Access Compliance Report

Public Rights-of-Way

(Curb Ramps)

Intersection ID: 27772	Main Street: BRIARWICK_LN	Cross Street: NORTH_COMMUNITY_HOUSE_RD	Location: NE
ADA ID: F60815098A12	Ramp Type: Perp	Initial Pass/Fail: Fail	Overall Compliance: No
Codes/Mitigation Info/Possible Solution		Field Measurements/Component Compliance	
Severity Score: 22.5

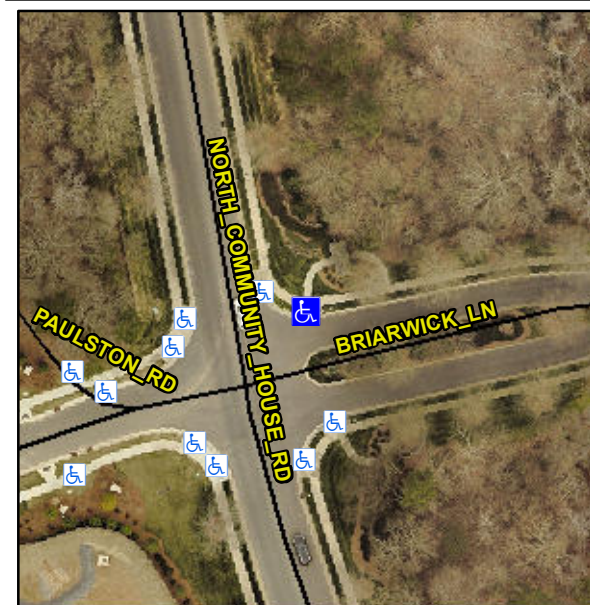
Not Found, R304.5.1, R304.2.2, R304.5.3

Compliance	Description	Data	Compliance	Description	Data
N/A	Ramp Length (in)	108.0	No	Ramp Slope (%)	8.5
No	Ramp Width (in)	43.5	No	Ramp XSlope (%)	2.1
N/A	Flare Type LT	N/A	N/A	Flare Type RT	N/A
N/A	Flare Slope LT (%)	N/A	N/A	Flare Slope RT (%)	N/A
N/A	Flare Traversable LT?	N/A	N/A	Flare Traversable RT?	N/A
N/A	Landing Length (in)	N/A	N/A	DWS Provided?	N/A
N/A	Landing Width (in)	N/A	N/A	DWS Contrast?	N/A
N/A	Landing Slope (%)	N/A	N/A	DWS Length (in)	N/A
N/A	Landing X Slope (%)	N/A	N/A	DWS Full Width?	N/A
N/A	Landing Curb? (Y/N)	N/A	N/A	DWS Offset (in)	N/A
N/A	Shared Landing?	N/A			
N/A	Gutter Ponding?	N/A	N/A	Gutter Slope (%)	N/A
N/A	Gutter Lip Ht (in)	N/A	N/A	Gutter X Slope (%)	N/A
N/A	Painted X Walk1?	No	N/A	Painted X Walk2?	N/A
	X Walk 1 Direction	To S		X Walk 2 Direction	N/A
N/A	X Walk 1 Width (in)	N/A	N/A	X Walk 2 Width (in)	N/A
	X Walk 1 Slope (%)	8.1		X Walk 2 Slope (%)	N/A
	X Walk 1 X Slope (%)	2.9		X Walk 2 X Slope (%)	N/A

Remove & Replace Entire Ramp.
